## Tachometer Signal - 75/90 Four Stroke

MERCURY/MARINER/TRACKER  
2000 & 2001 Model Year 75/90 Four Stroke  
Serial Number 0G960500 thru 0T320116

**Remote Control Electrical Harness Adaptor 84-858740T2**

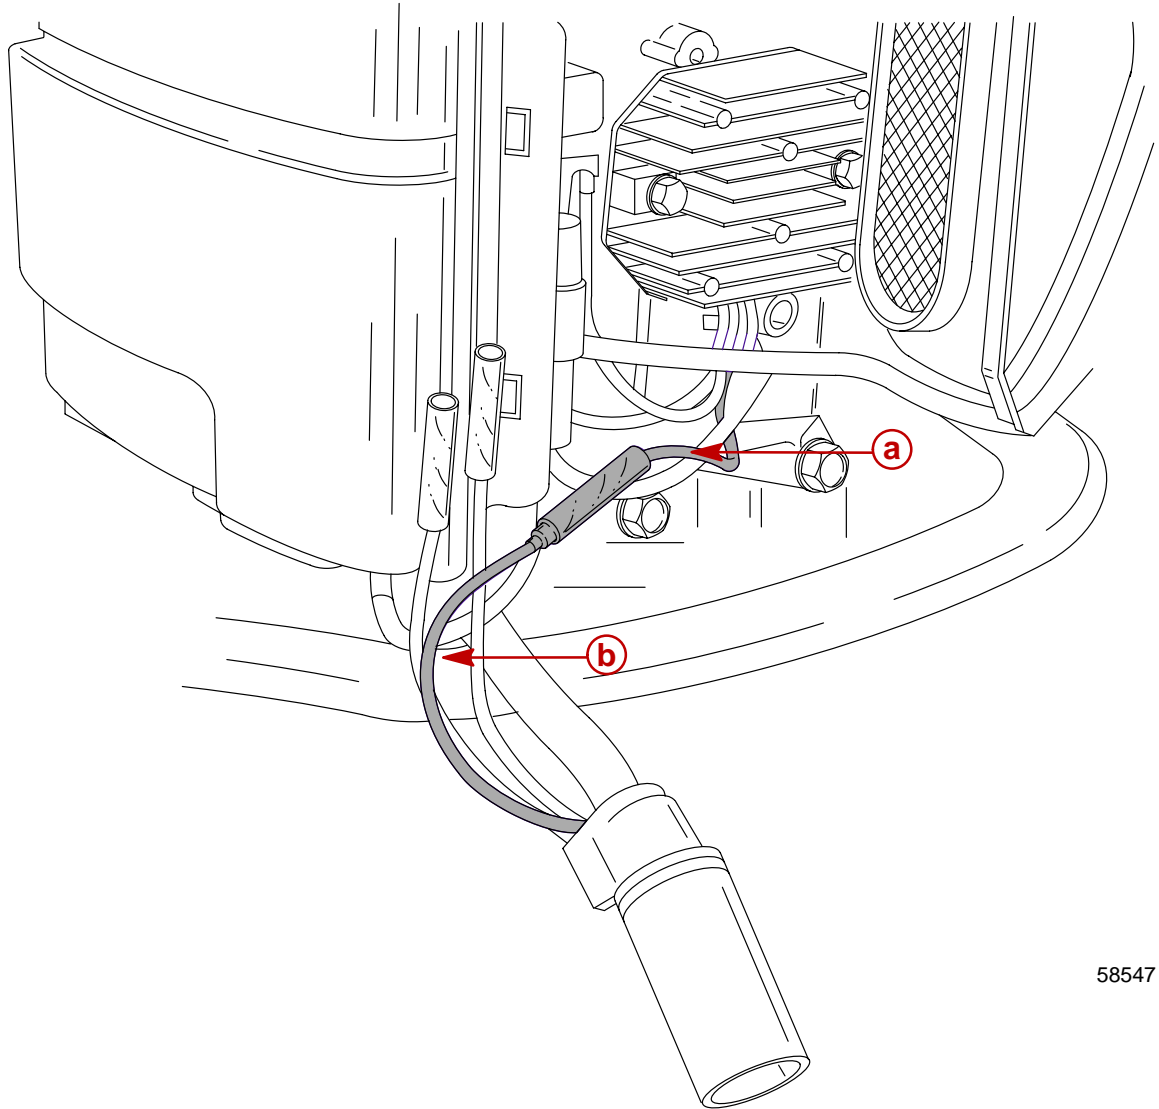
75/90 four stroke products beginning with serial number 0T320117 have a new remote control electrical harness adaptor 84-858740T2 installed at the factory. This new harness adaptor will provide an accurate tachometer reading with all tachometers.

In-dash tachometers that exhibit the “flutter” and low rpm reading on the models listed in this advisory can be corrected. Remove the existing remote control electrical harness adaptor and install a new harness adaptor 84-858740T2. This new harness adaptor has an additional gray wire exiting the connector with the two power trim wires. The additional gray wire connects to the voltage regulator green/white wire. An installation instruction sheet is provided with the new harness adaptor. The new harness adaptor will supersede the previous 84-858740T1 harness adaptor.

Qty. 1    84-858740T2 Remote Control Electrical Harness Adaptor.
